Addendum #2

Date: July 2, 2019

Beaufort Arsenal Window Restoration Project RFP 2019-107

Ventilation Details
for Plastic Window
Coverings

1 DIAGRAMMATIC PLAN DETAIL- MUSEUM WINDOWS
1" = 1'-0"

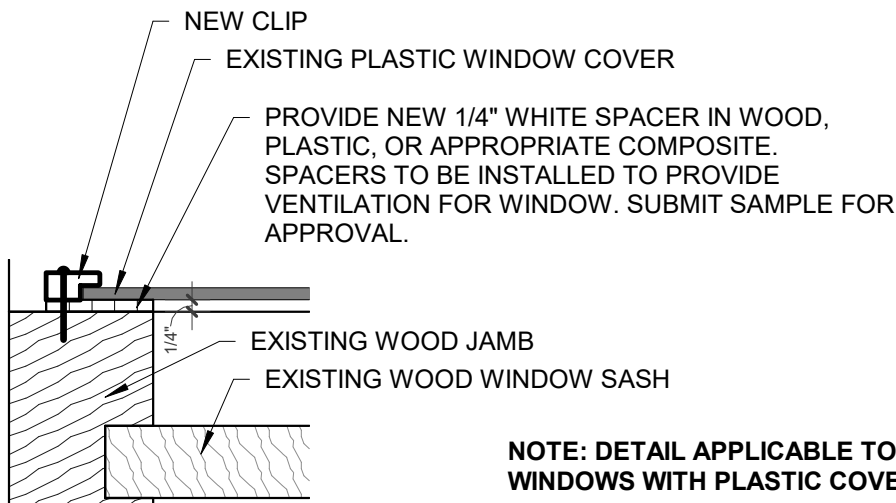
- a. Window 19 is a casement window. The casement window is to be operable. See General Window Notes item 5 on Sheet A601 for additional notes on hardware. Delete specified surface bolts. Install one solid brass casement latch set made by House of Antique Hardware (finish- unlacquered brass, product number R-09BM-8811). Plywood to be removed from opening.
2. ADD: Ventilation details for plastic window covers in museum space. See attached details on sheet SK-01.

NOTE: DETAIL APPLICABLE TO ALL WINDOWS WITH PLASTIC COVERS.

TRIM BOTTOM OF PLASTIC PANEL TO PROVIDE 1/2" AIR GAP BETWEEN THE BOTTOM OF THE PLASTIC WINDOW PANEL AND THE WINDOW STOOL.

2 DIAGRAMMATIC PLAN DETAIL-SPACER FOR PLASTIC WINDOW COVERINGS
3" = 1'-0"

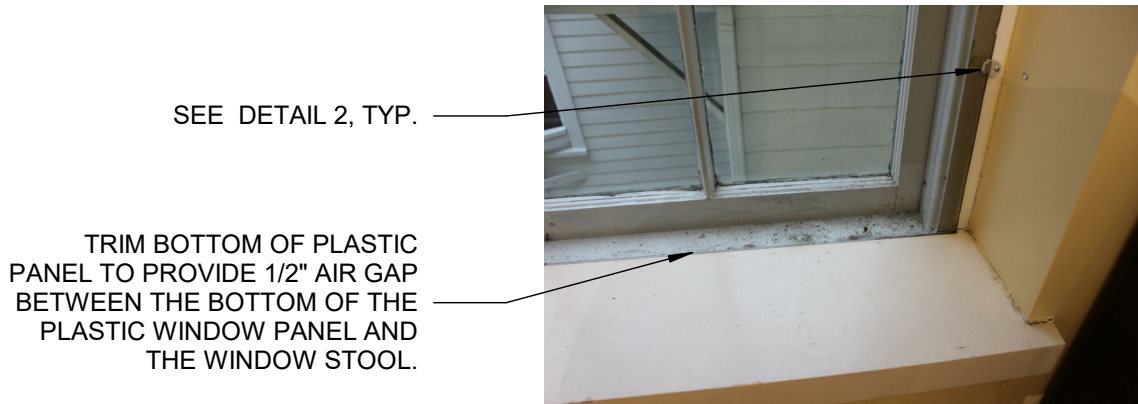
SEE DETAIL 2, TYP.
